Draft Off-Cycle Emissions GTR 14 and 15 September, 2005

Edits from 1st Editorial Committee meeting are in **Red**
Edits from 2nd Editorial Committee meeting are in **Blue**

Figure X: Illustration of Ambient Altitude and Temperature Conditions for Option A

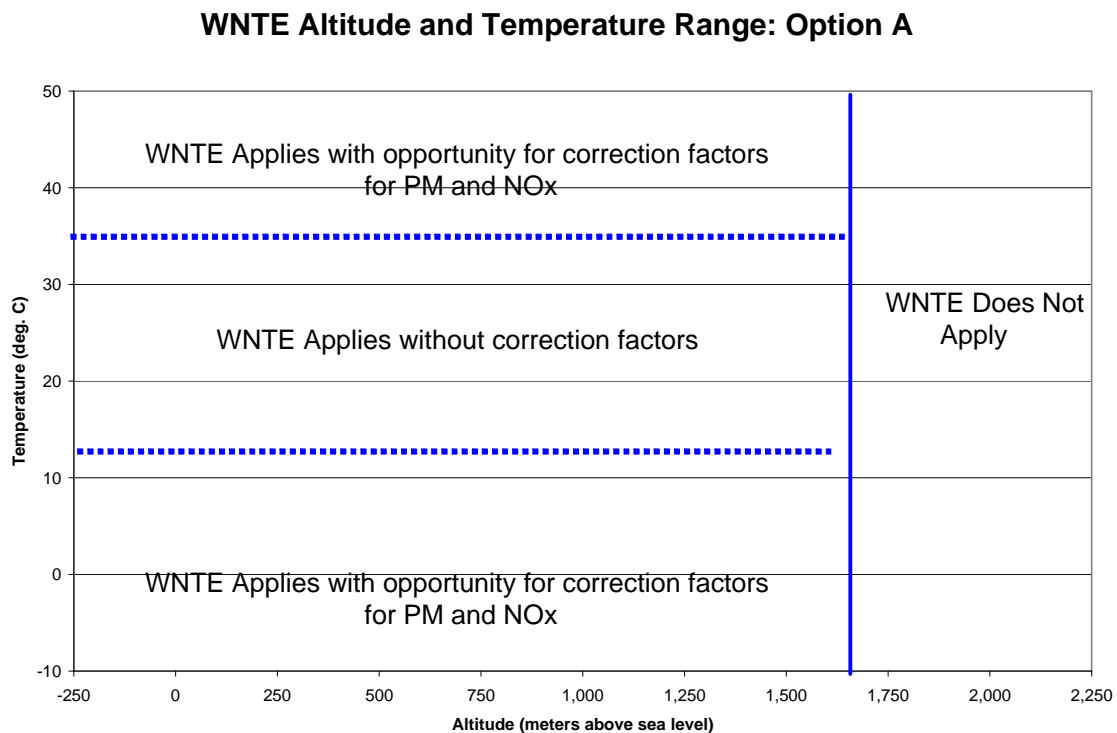
Editorial Comment: Editorial Committee has identified the altitude cut point as an issue to be further discussed by the Plenary group.

Editorial comment: EMA and OICA would like the current altitude value to be expressed in an equivalent barometric pressure value

Editorial comment: integrate section 7.3 into this section

Figure Y: Illustration of Ambient Altitude and Temperature Conditions for Option B

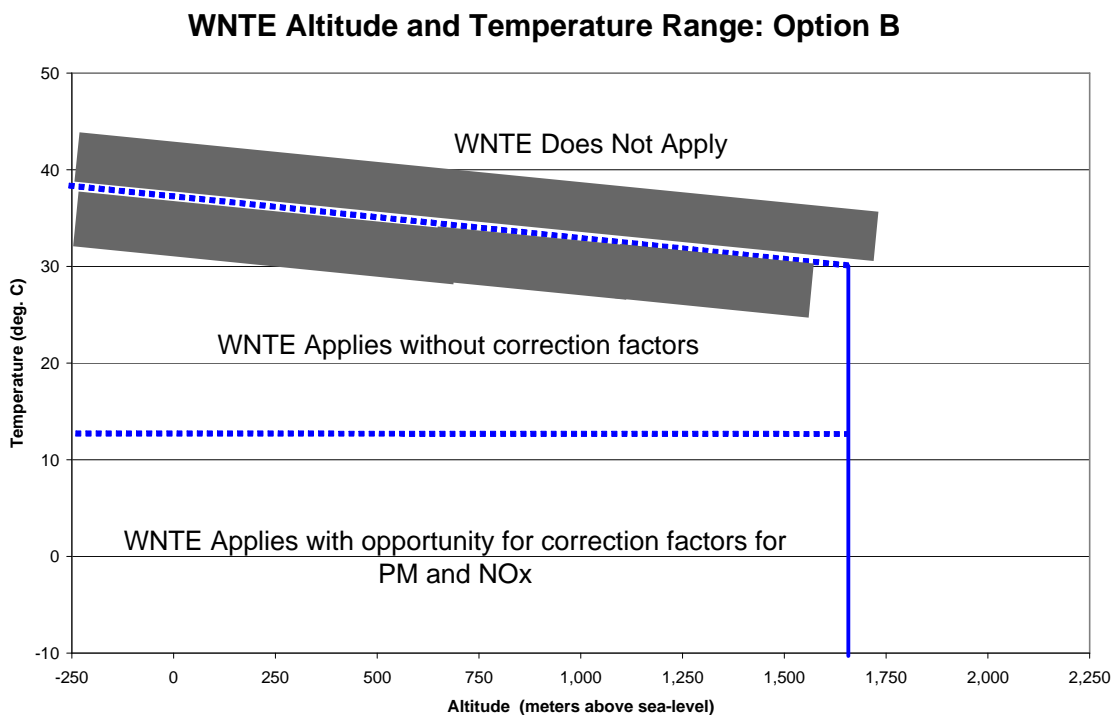
Issues/Concerns/Follow-up:

1) Desire not to design for altitudes above 1000 meters for countries where less than 2% VMT (Vehicle Miles Traveled) is spent at such altitude (argument is that high altitude

requirements drive engine design, both hardware and software, which ultimately applies to low altitude operation as well). Not clear that is the case.

2) Altitude requirements drive design requirements in terms of cooling capacity, cab dimensions.

3) Special consideration has to be given to countries at altitudes greater than 1680 meters.

4) Plenary group to provide suggestion whether to split out altitude ranges and how to address cost benefit discussion.

5) Need to understand specific design issues and the potential for an altitude engine control strategy to resolve the stated concerns.

6) Need to consider the lost benefit of harmonization.

7) Need to consider aftermarket sales/cross border migration

8) Altitude tiers that could be considered: 1000 meters and below, <1680 meters, and <2000 meters

Figure 1. Example Not-To-Exceed Control Area When C Speed < 2,400 rpm

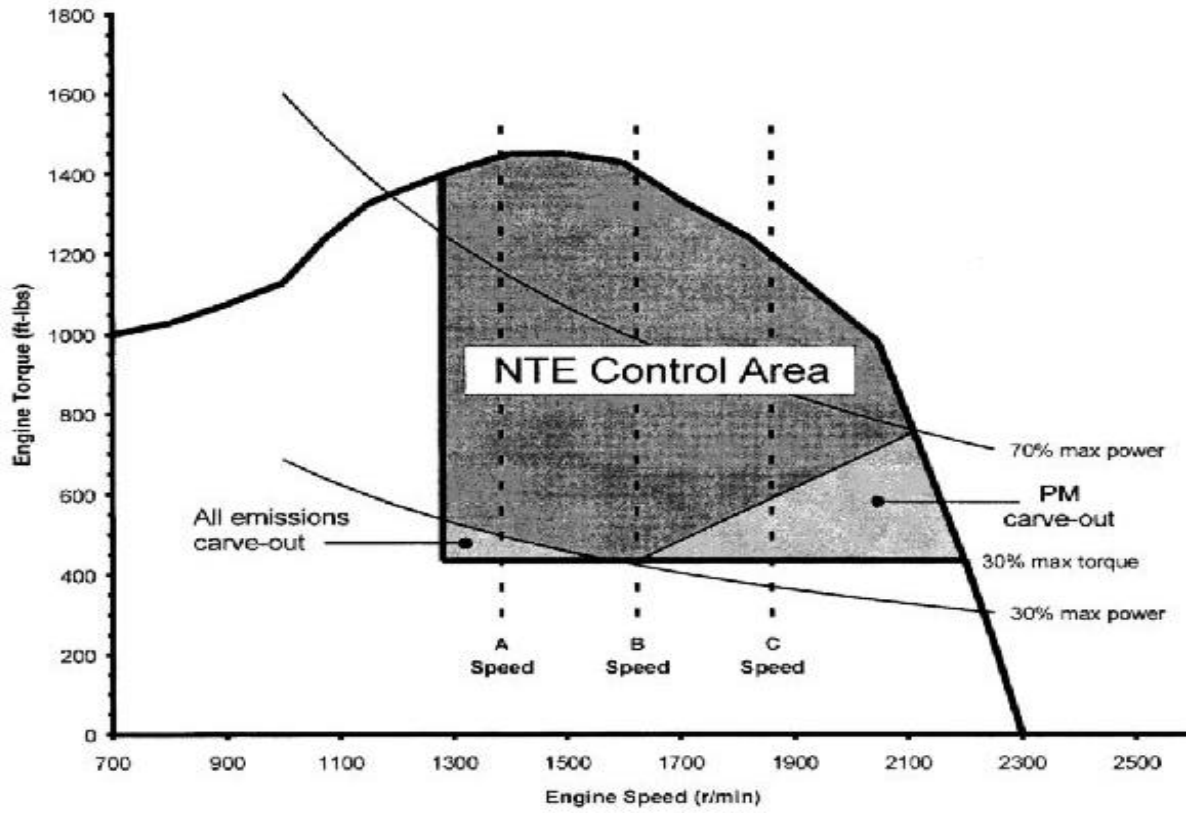
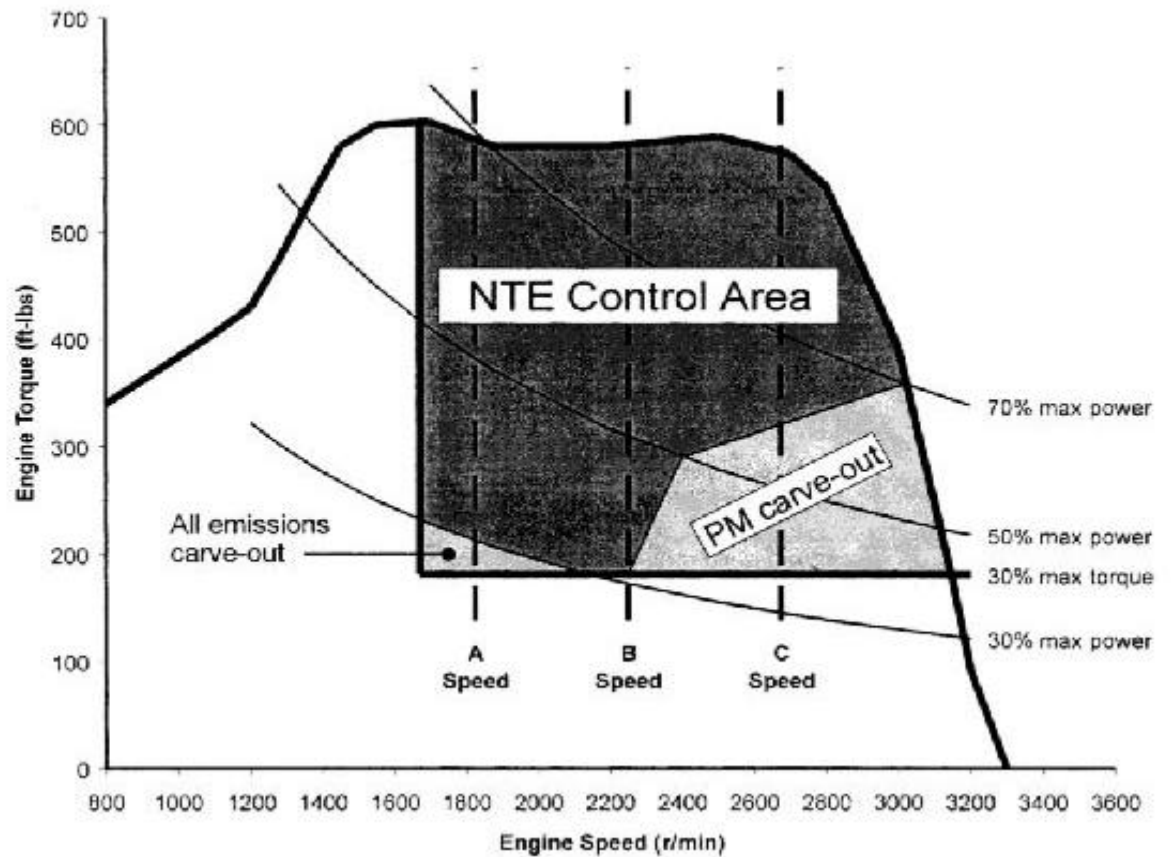
Editorial Comment: Will update diagrams to correspond with final control area established in GTR and will add example figures without PM carve out.
